AMENDMENTS TO THE DRAWINGS

### REMARKS

Fig. 14

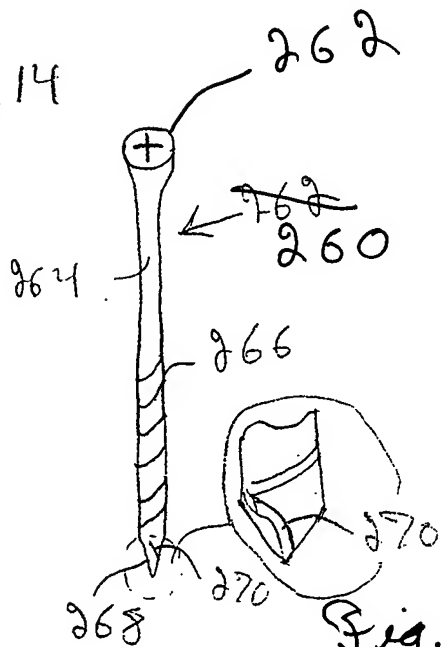
The Examiner noted that Figs. 9 and 14 had inserts that were not properly identified. However, only the view in the insert of Fig. 14 is a modified view. Thus, this insert has been labeled Fig. 14A. The insert of Fig. 9 depicts an expanded view. This has now been properly recited in the brief description of the drawings. Since the insert of Fig. 9 is not a modified view, Applicants respectfully believe that a separate figure number is not needed or suitable for this insert.

Formal drawings are enclosed replacing sheets 1-5 as filed. Also, Figs. 14, 18A and 18B have corrections to reference numbers as described in the remarks below. The insert of Fig. 14 has now been labeled Fig. 14A. Marked up and clean sheets are enclosed for the sheets with Figs. 14, 18A and 18B with the marked up sheets immediately after this page and clean sheets at the end of the Amendment.

Fig. 18A

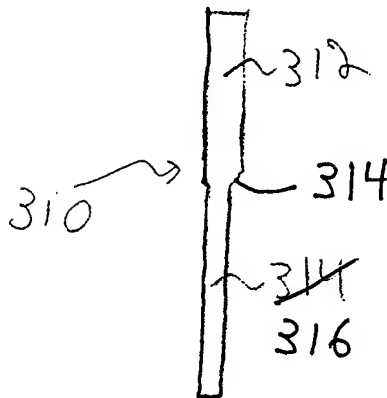
The Examiner noted that the reference numbers 260 and 316 were omitted from the figures. These have been added to correspond with the description in the text. No new matter is introduced.
